## **CHEYENNE VAMC MRI SITE PREP**

Project # 442-DSI-400

**DATE: November 13, 2015**

### **ADDENDUM NO. 3**

| CONSULTANTS: |  |  |  | ARCHITECT/ENGINEERS:  |  |  |  | Drawing Title<br>Floor Plan, Reflected Ceiling Plan and Roof Plan |  |  |  | Project Title<br>Cheyenne VAMC MRI Site Prep |  |  |  | Office of Construction and Facilities Management |  |  |  |

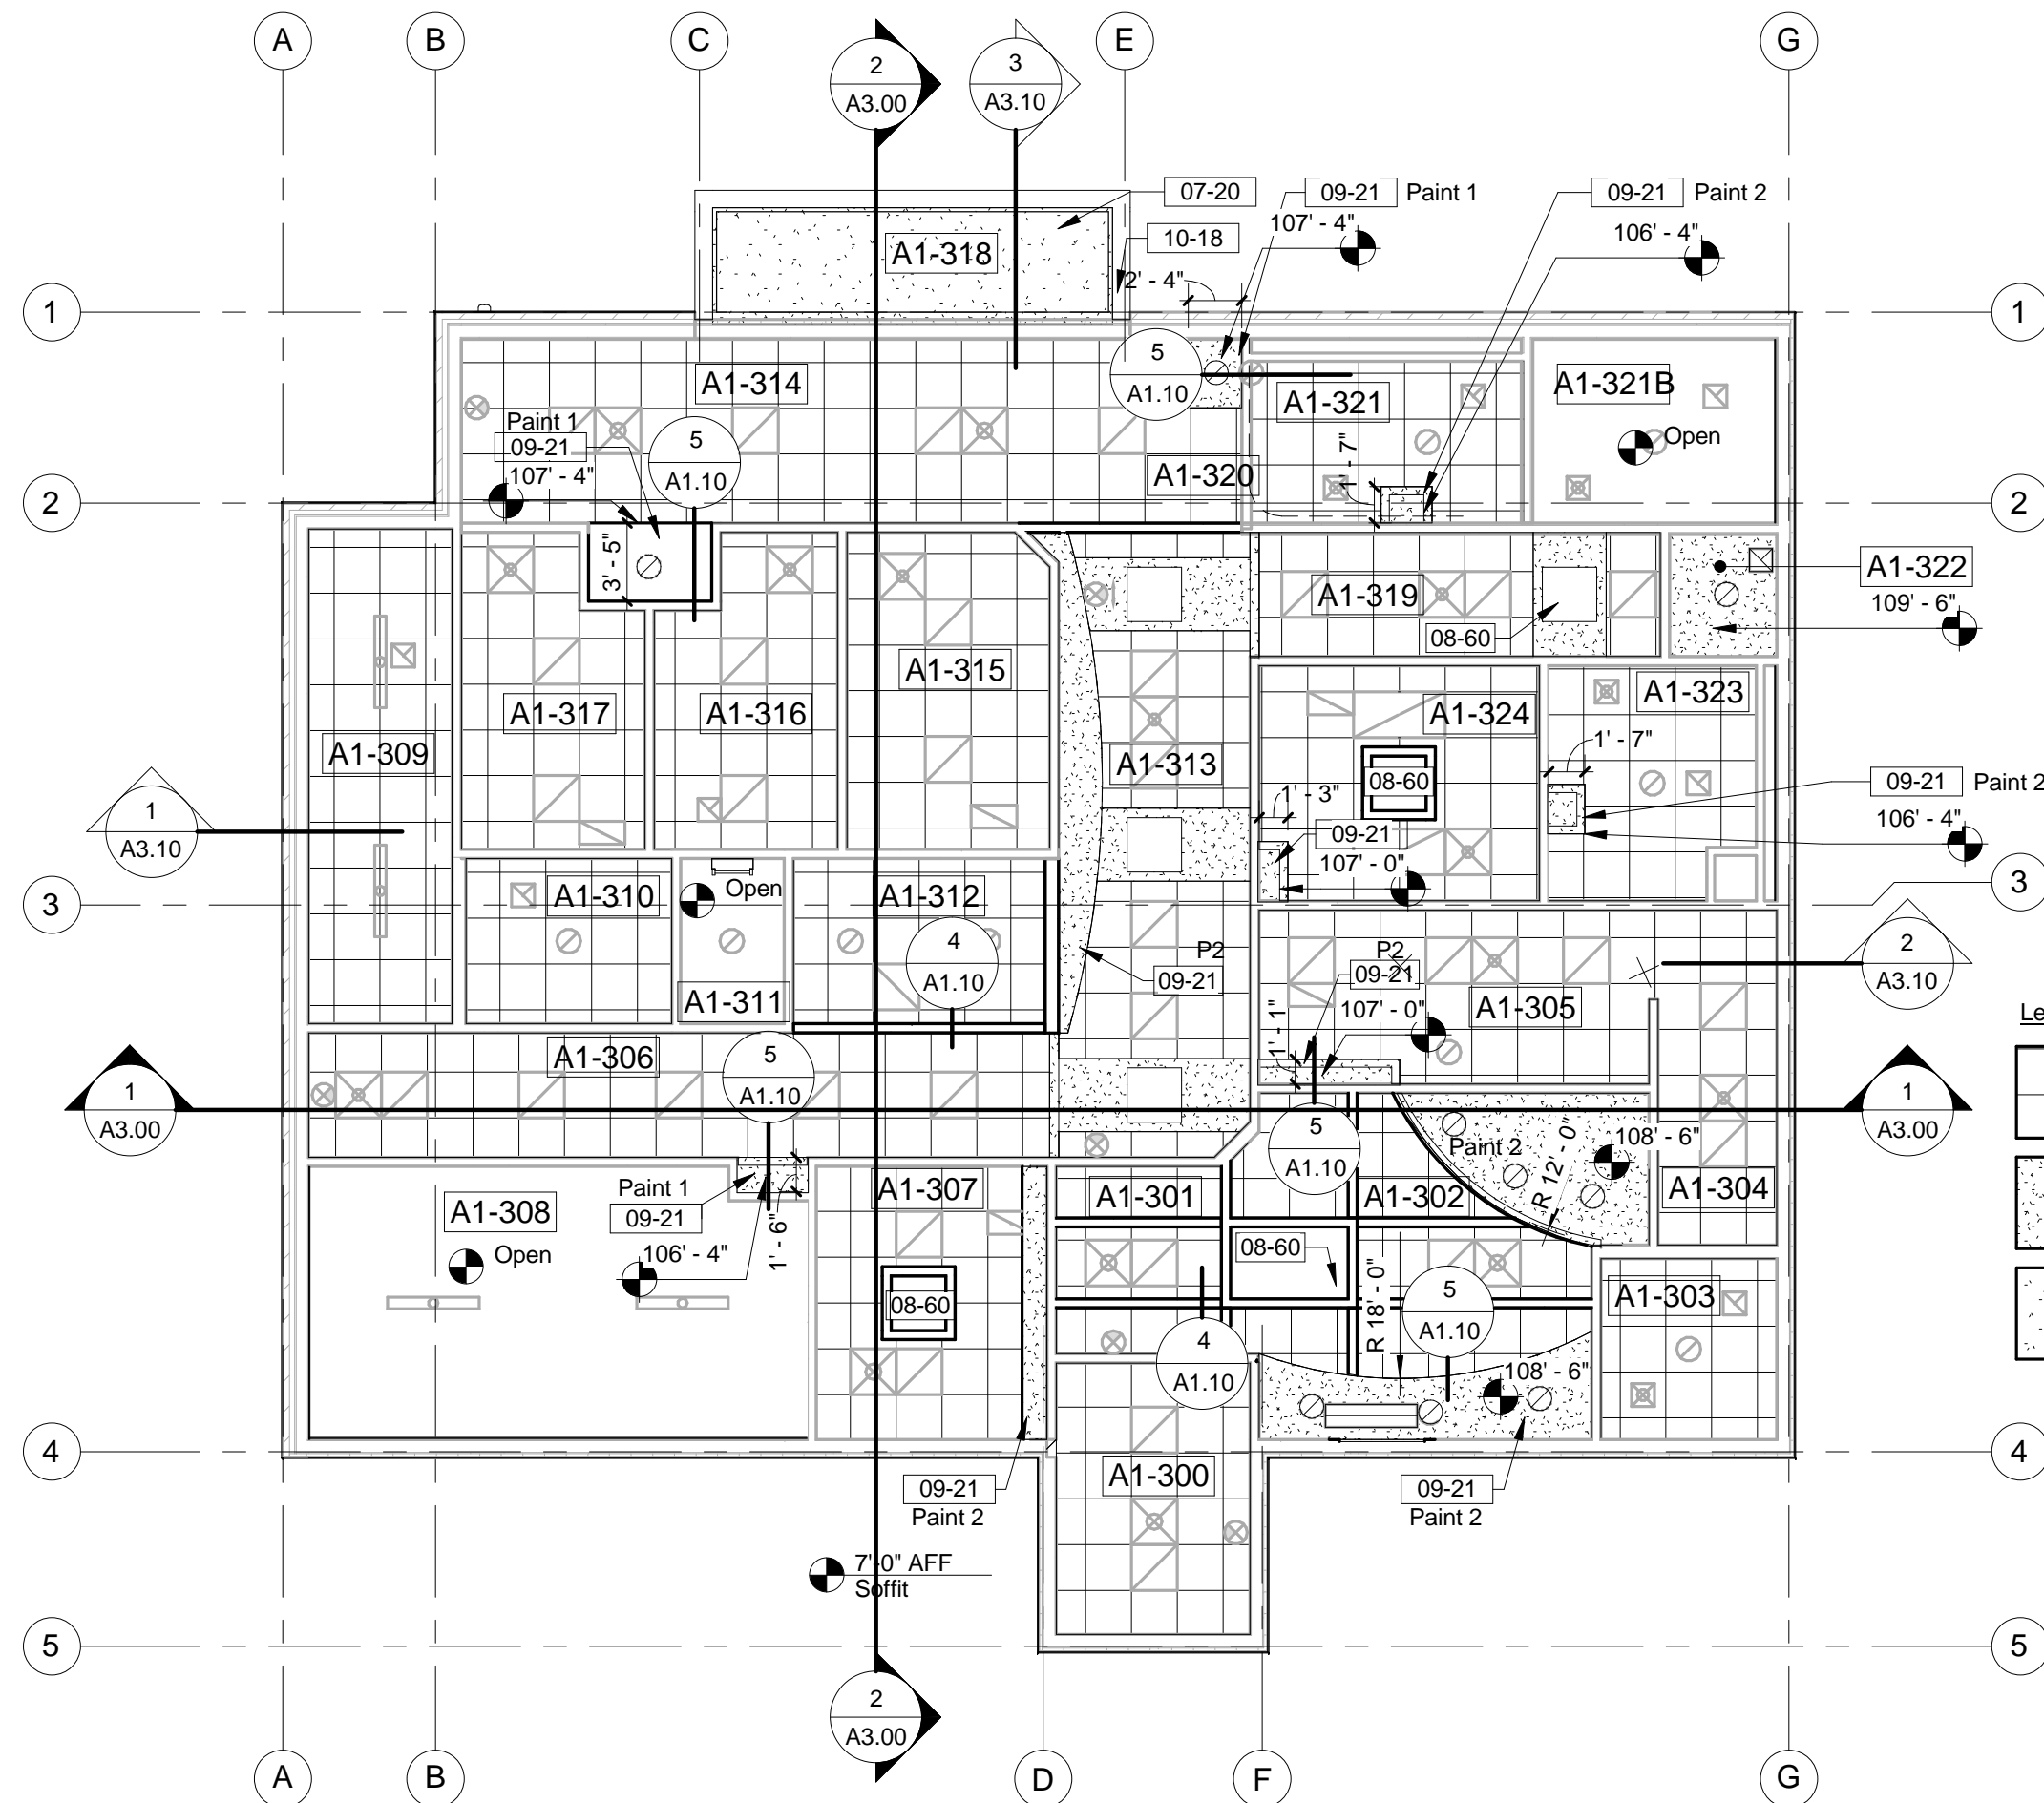
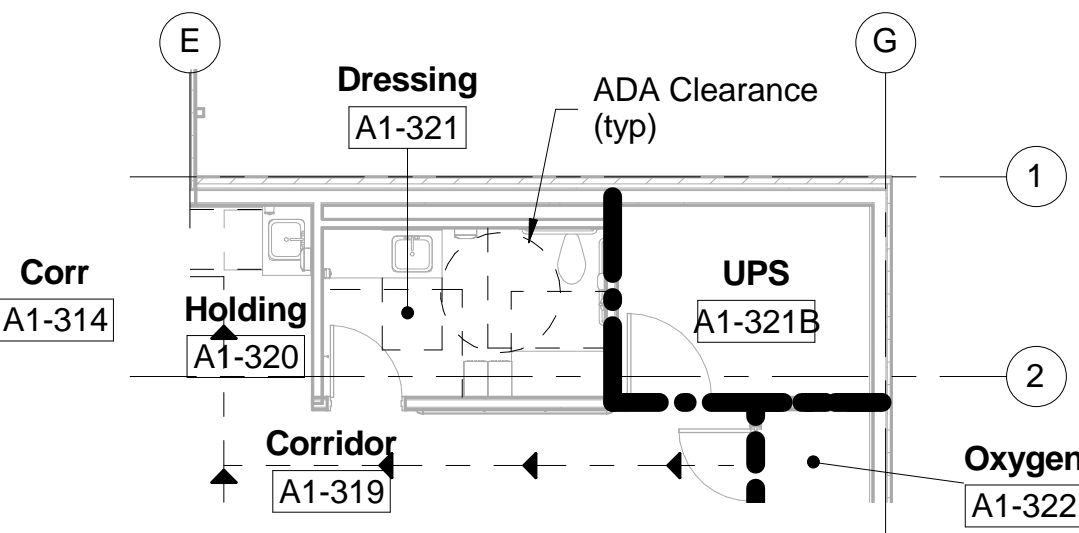
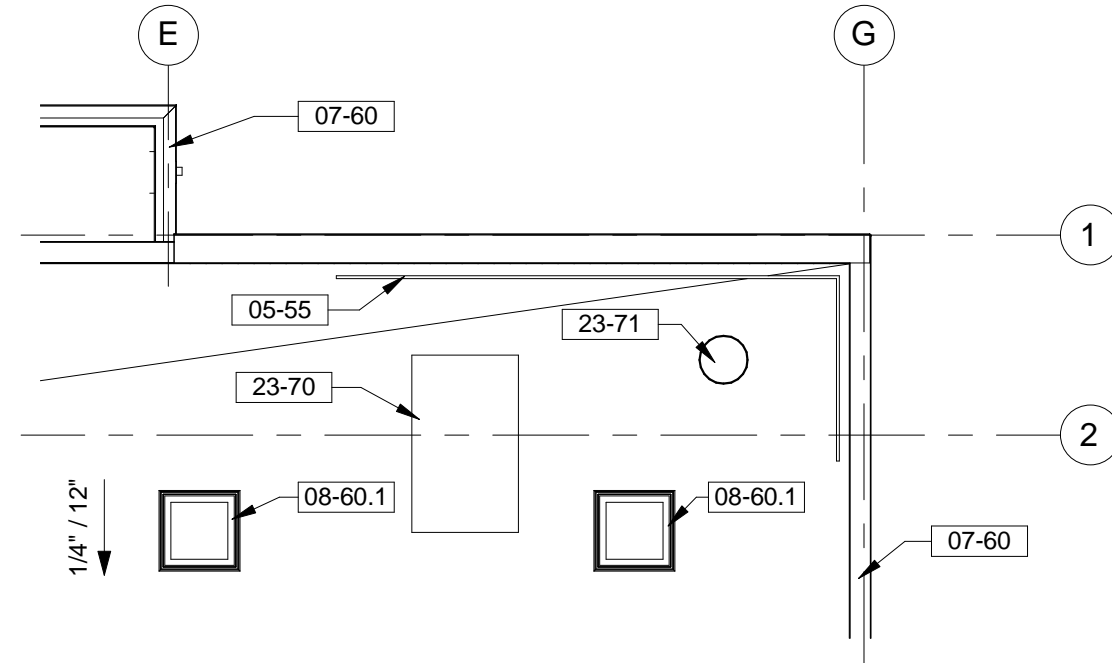
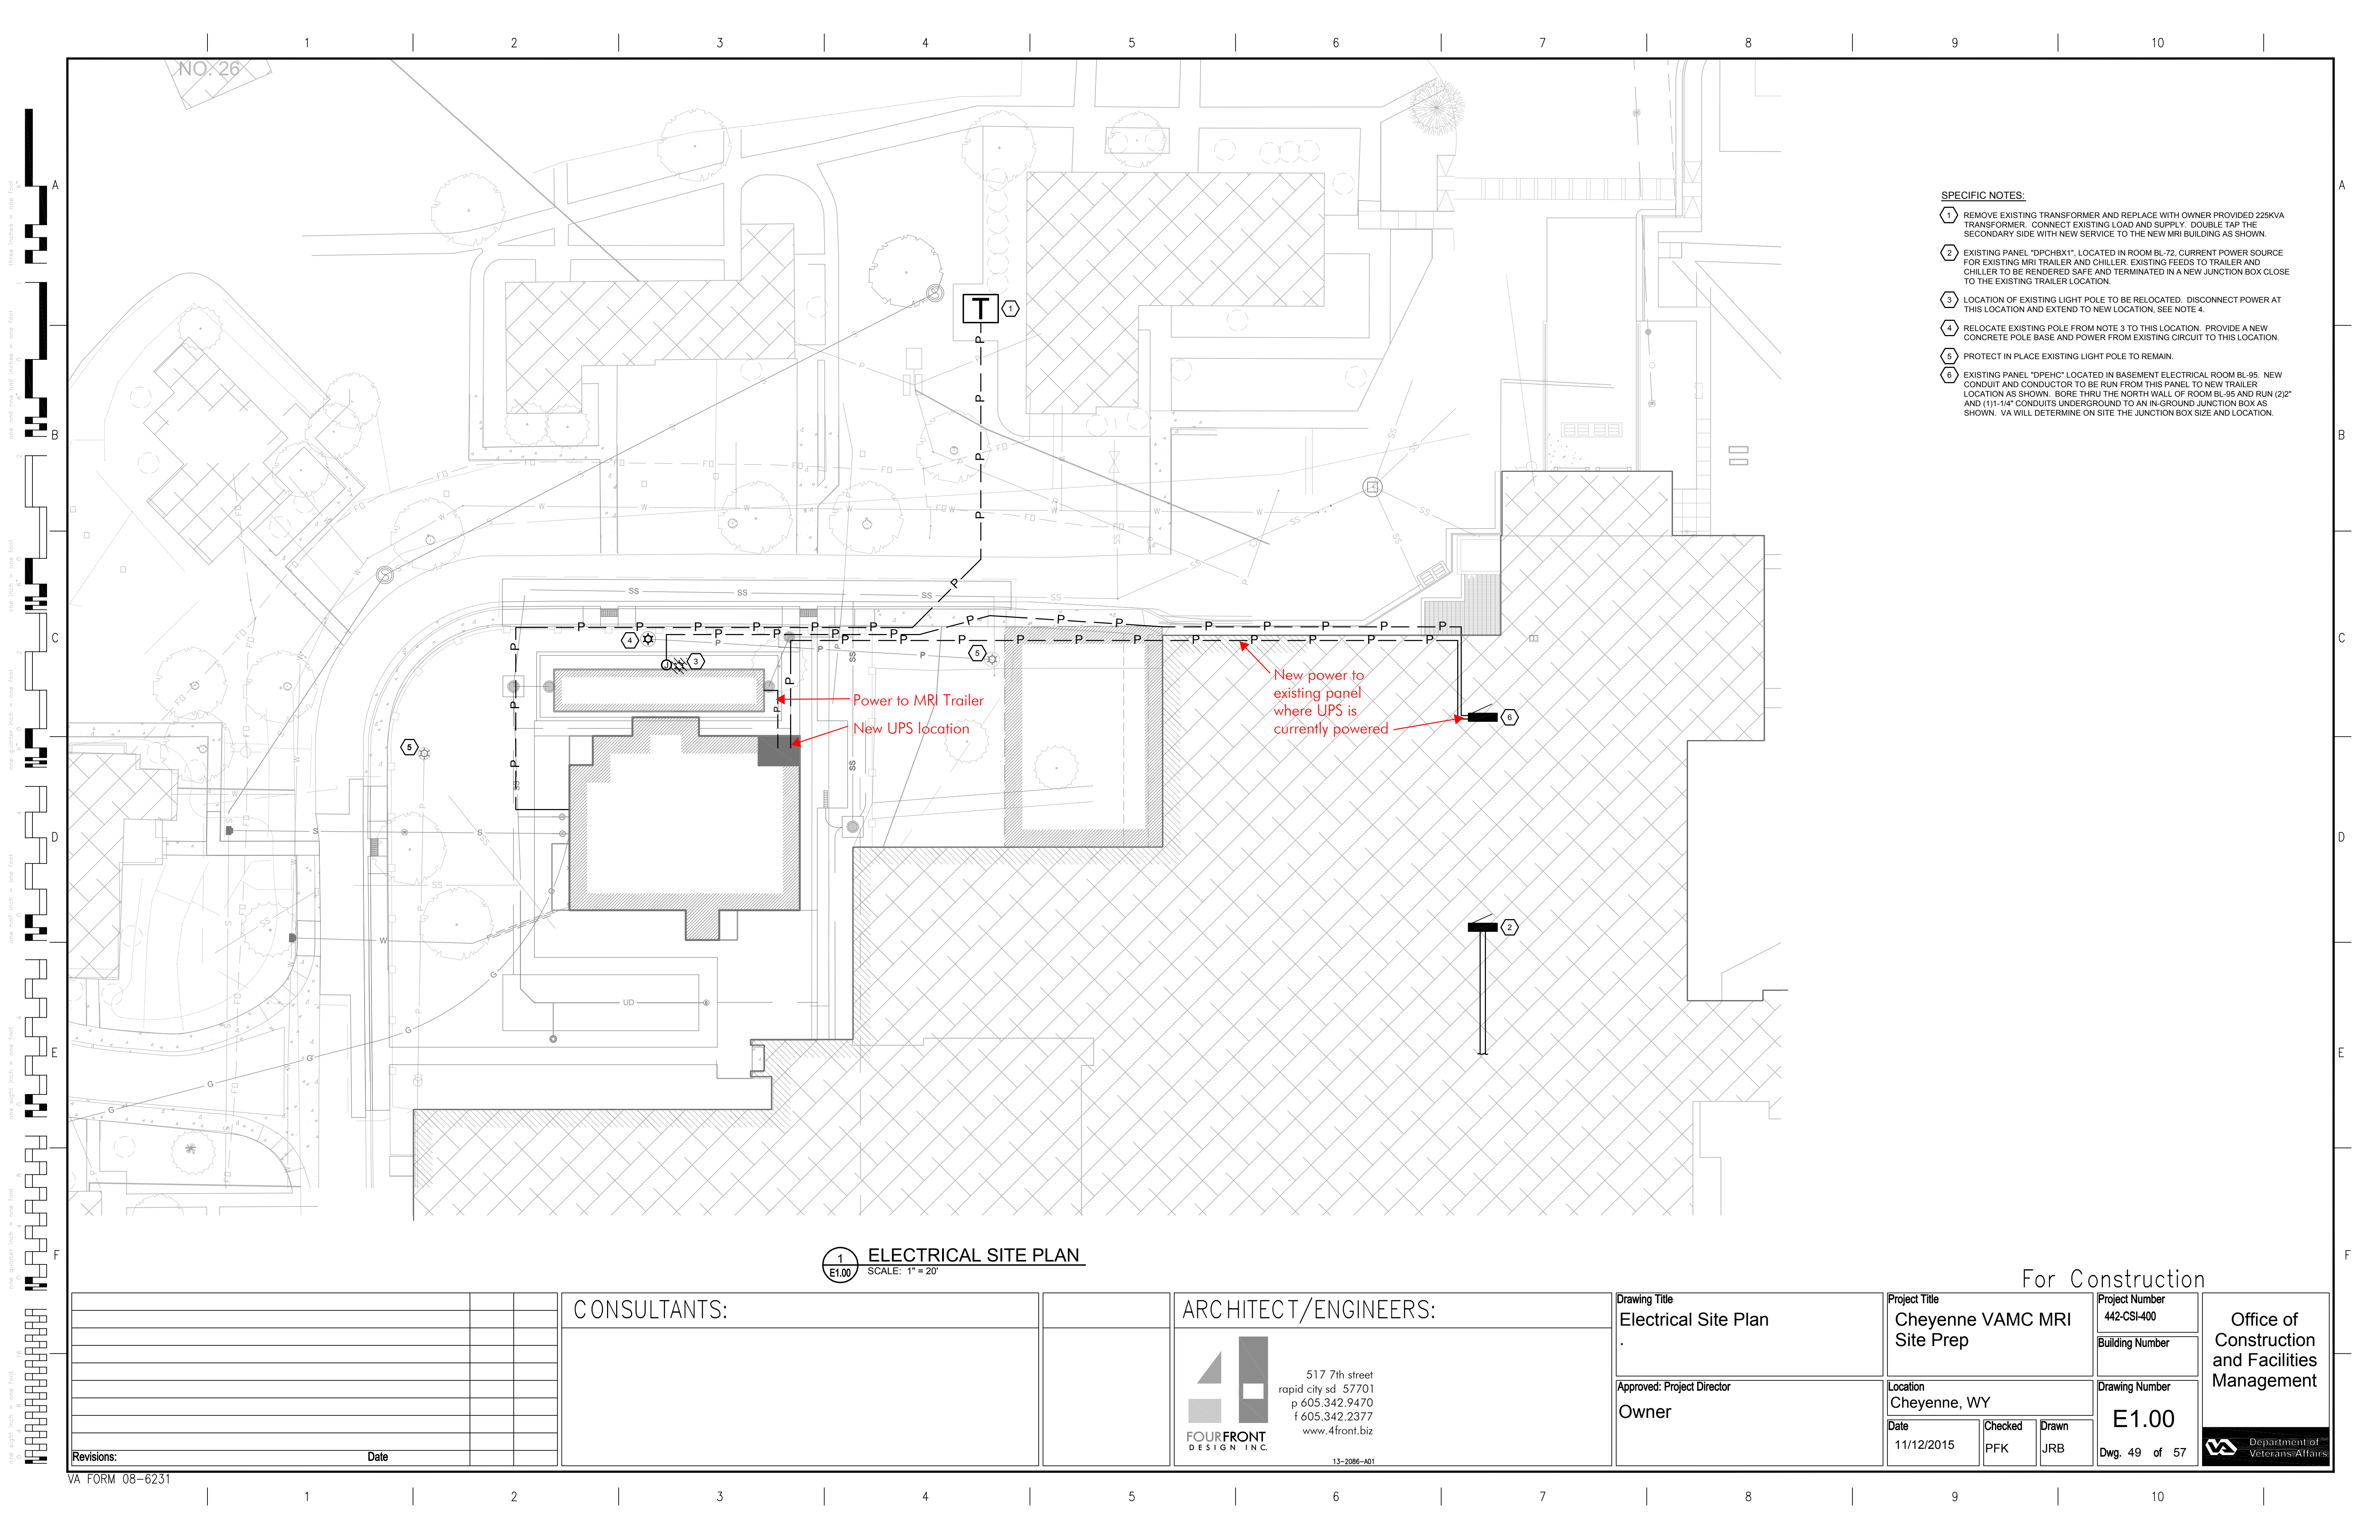
- Add UPS room A1-321B to floor plan as shown, moving Dressing A1-321 and Holding A1-320 over to allow space for the UPS room.
- Adjust ceilings per new floor plan. UPS room A1-321B to be open to structure.

- UPS Room to be concrete floor, rubber base and walls to be paint 4.
- Add door 321B, 3'-6"x7'-0", 2 hour rated, panel WD-F, frame HM-001, hardware HW-2.

- Add 1 1/2" pipe guardrail 42" high on North and East sides of the roof as shown on the roof plan. Guardrail to be mounted to the roof, 6" inside the parapet wall. Color to be selected by architect.

- Provide (3) AC outlets, (1) Data outlet in UPS room A1-321B.
- Provide (2) explosion proof chain hung T5 lights in UPS room A1-321B.
- UPS to connect to existing panel/circuit.

- Provide new feeders to UPS.
- UPS to remain in existing location and operational until new building is complete.
- Relocation of UPS to be coordinated with VA staff.

- Electrical contractor to provide connection to new air handling unit.
